Access Compliance Report

Public Rights-of-Way

(Curb Ramps)

Intersection ID: 13382	Main Street: E_CATHERINE_ST	Cross Street: S_COLLEGE_ST	Location: S
ADA ID: C31F1A594FC1	Ramp Type: Perp	Initial Pass/Fail: Fail	Overall Compliance: No
Severity Score: 13.75			
Codes/Mitigation Info/Possible Solution		Field Measurements/Component Compliance

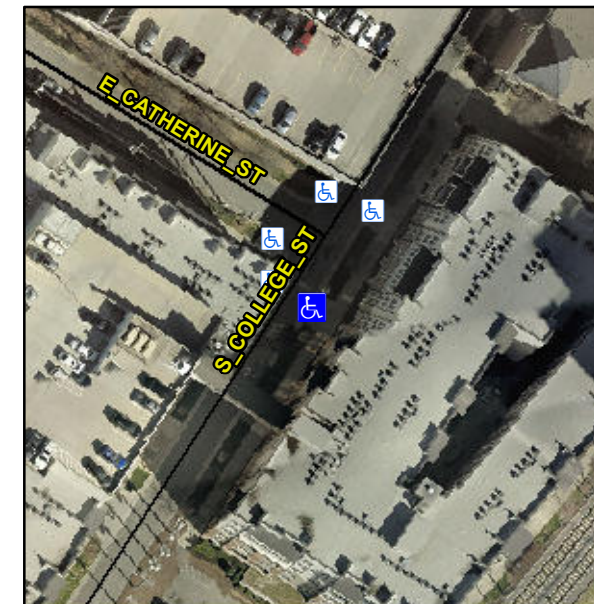
PROW/ADA:

Not Found, R304.2.2

Compliance	Description	Data	Compliance	Description	Data
N/A	Ramp Length (in)	95.5	No	Ramp Slope (%)	10.0
Yes	Ramp Width (in)	48.0	Yes	Ramp XSlope (%)	3.2
N/A	Flare Type LT	N/A	N/A	Flare Type RT	N/A
N/A	Flare Slope LT (%)	N/A	N/A	Flare Slope RT (%)	N/A
N/A	Flare Traversable LT?	N/A	N/A	Flare Traversable RT?	N/A
N/A	Landing Length (in)	N/A	N/A	DWS Provided?	N/A
N/A	Landing Width (in)	N/A	N/A	DWS Contrast?	N/A
N/A	Landing Slope (%)	N/A	N/A	DWS Length (in)	N/A
N/A	Landing X Slope (%)	N/A	N/A	DWS Full Width?	N/A
N/A	Landing Curb? (Y/N)	N/A	N/A	DWS Offset (in)	N/A
N/A	Shared Landing?	N/A			
N/A	Gutter Ponding?	N/A	N/A	Gutter Slope (%)	N/A
N/A	Gutter Lip Ht (in)	N/A	N/A	Gutter X Slope (%)	N/A
N/A	Painted X Walk1?	No	N/A	Painted X Walk2?	N/A
	X Walk 1 Direction	To NW		X Walk 2 Direction	N/A
N/A	X Walk 1 Width (in)	N/A	N/A	X Walk 2 Width (in)	N/A
	X Walk 1 Slope (%)	2.8		X Walk 2 Slope (%)	N/A
	X Walk 1 X Slope (%)	4.6		X Walk 2 X Slope (%)	N/A

Remove & Replace Entire Ramp.
